APPLICATION FOR MODIFICATION ASSESSMENT REPORT

Application Number:	Mod2019/0029
----------------------------	--------------

Responsible Officer:	Renee Ezzy
Land to be developed (Address):	Lot CP SP 10040, 46 Victoria Parade MANLY NSW 2095
Proposed Development:	Modification of Development Consent DA367/2010 granted for demolition works and construction of a residential flat building
Zoning:	Manly LEP2013 - Land zoned R3 Medium Density Residential
Development Permissible:	Yes
Existing Use Rights:	No
Consent Authority:	Northern Beaches Council
Delegation Level:	NBLPP
Land and Environment Court Action:	No
Owner:	Proprietors of Strata Plan 10040
Applicant:	BBF Town Planners

This report provides an assessment of a Modification of Development Consent (MOD2019/0029) for a five (5) storey residential flat building with basement parking at No. 46 Victoria Parade, Manly.

Figure 1 - Boundary setbacks to Substation - Source: Survey Plan supplied with application prepared by Veris Australia

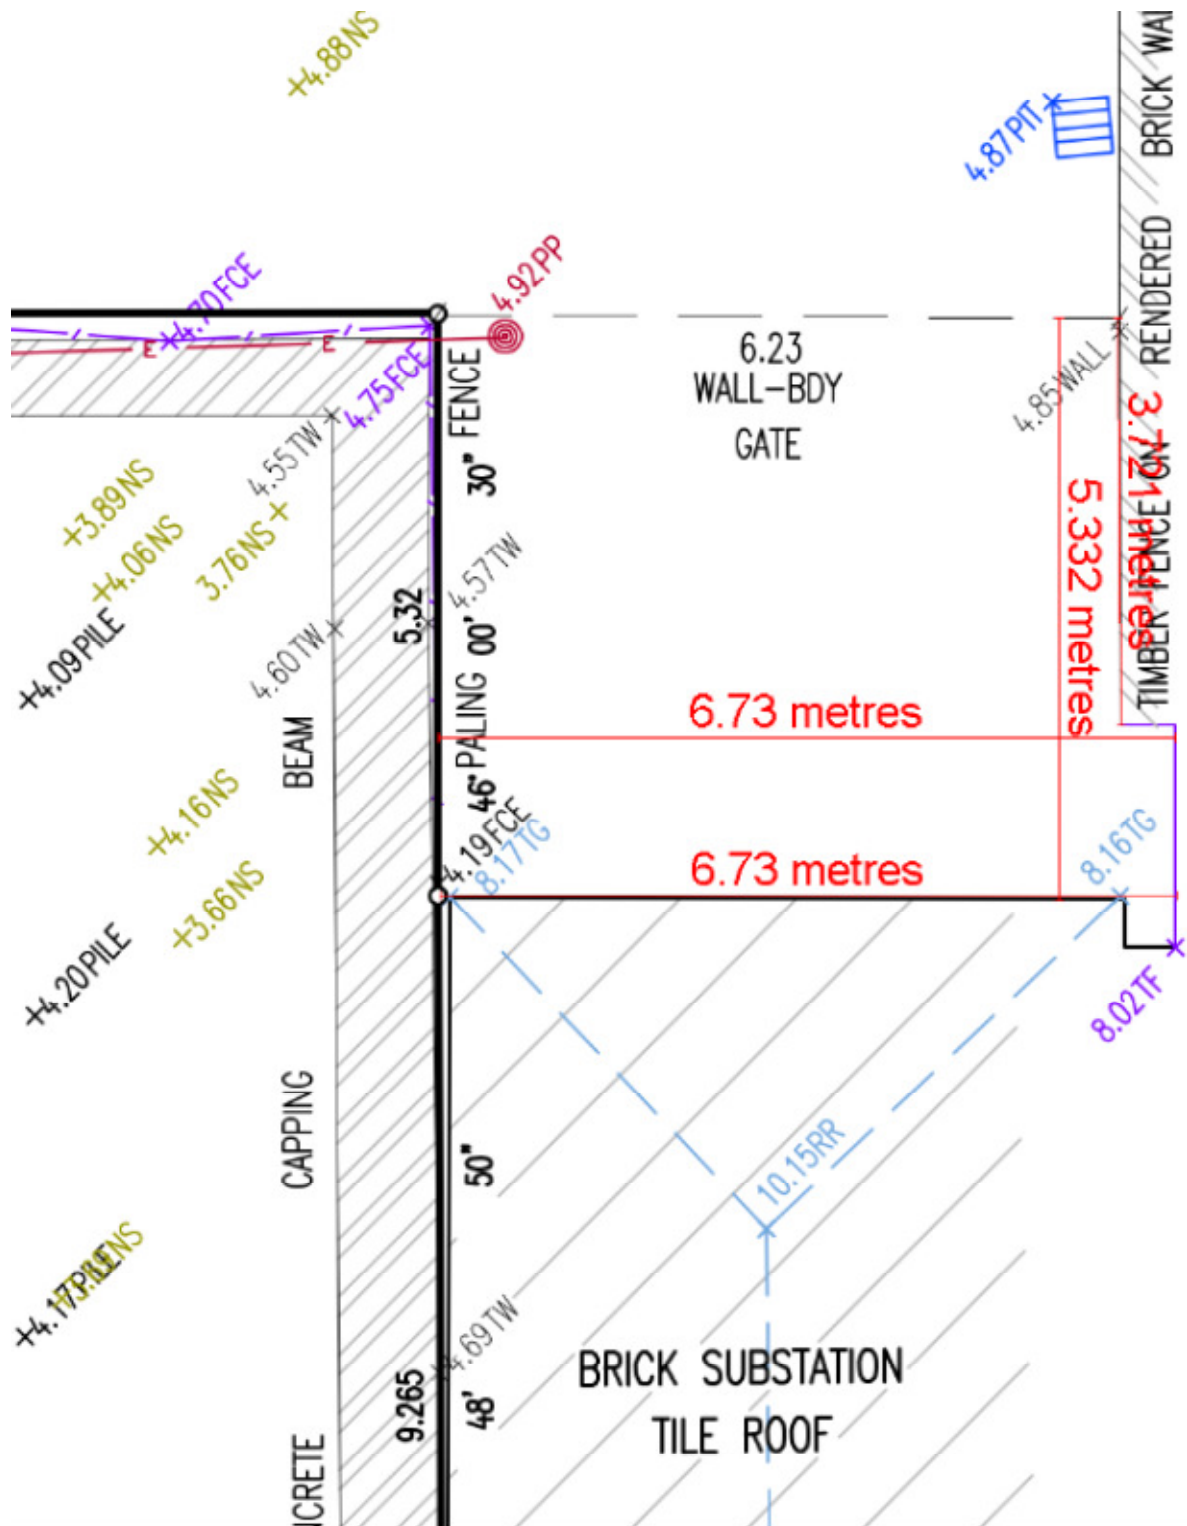
This setback measurement is taken from the boundary of the property on the southern side of the substation. This southern boundary contains a step in front of the substation facade resulting in a varying width for the substation of between 6.23m and 6.73m. None of the previous reports from the court proceedings or subsequent modifications clarify from which point the setback was taken. As the setback on the survey plan at the Dungowan building line is 6.23m, it is this point that has been used for the purpose of calculating setbacks for this assessment.

Adopting this dimension of 6.23m, the changes proposed to the Level 1 and Level 2 facade will result in a setback to the substation of 3.2m and a setback to the southern substation boundary of 9.43m. The original condition 1 references a requirement for the setback to the building facade of 11m and to the balcony of 9.5m. This results in a further departure of 1.5m from the court consent.

Figure 2 and 3 - Level 3 and Level 4 removal of corner balcony and relocation of planter previously within view corridor

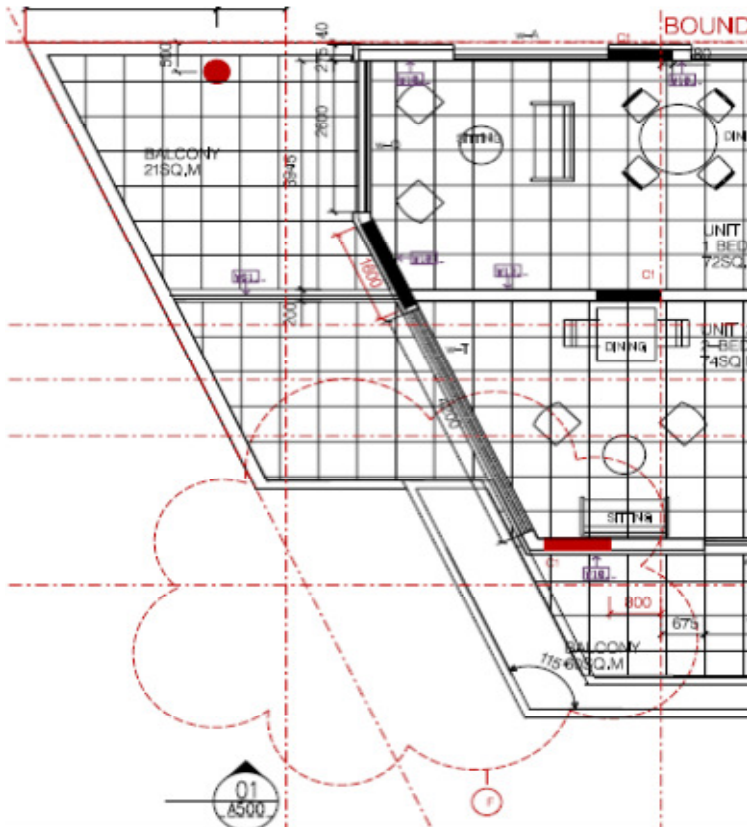
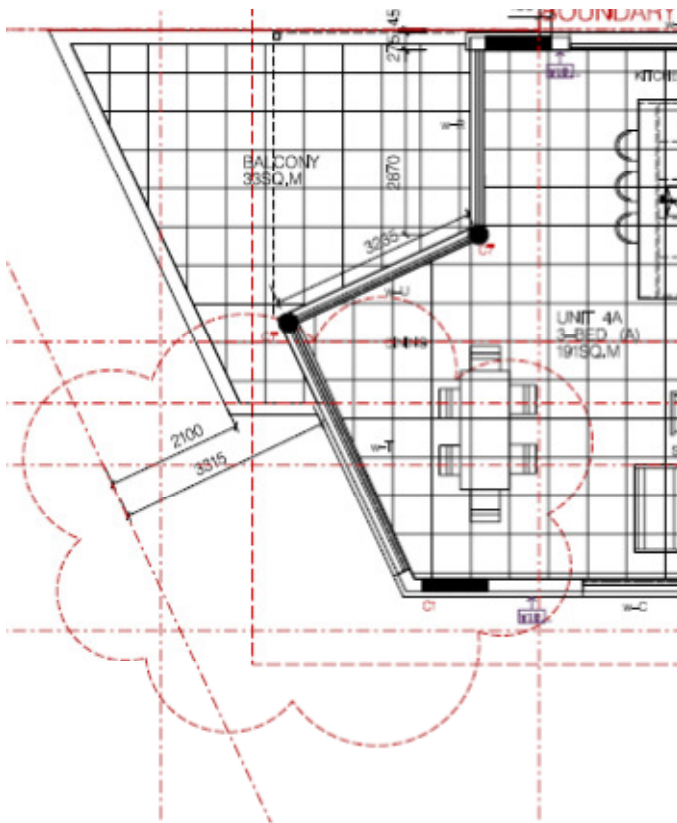
The proposal with the amended balcony design provides for view sharing for the existing and future occupants of the adjoining apartments at the front of 42-44 Victoria Parade.

Figure 4 - View corridor analysis at Level 4 (source: Applicant View Analysis)

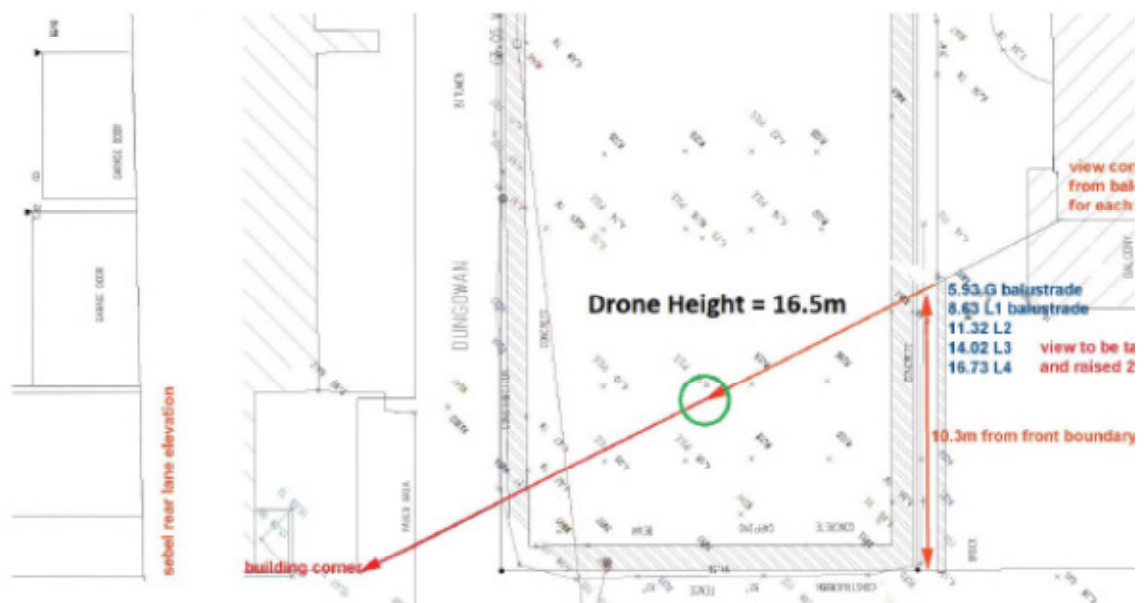
The proposed modifications are considered to improve the previous development's response to the view corridor across this site and is not considered to contribute to accumulated view loss creep.
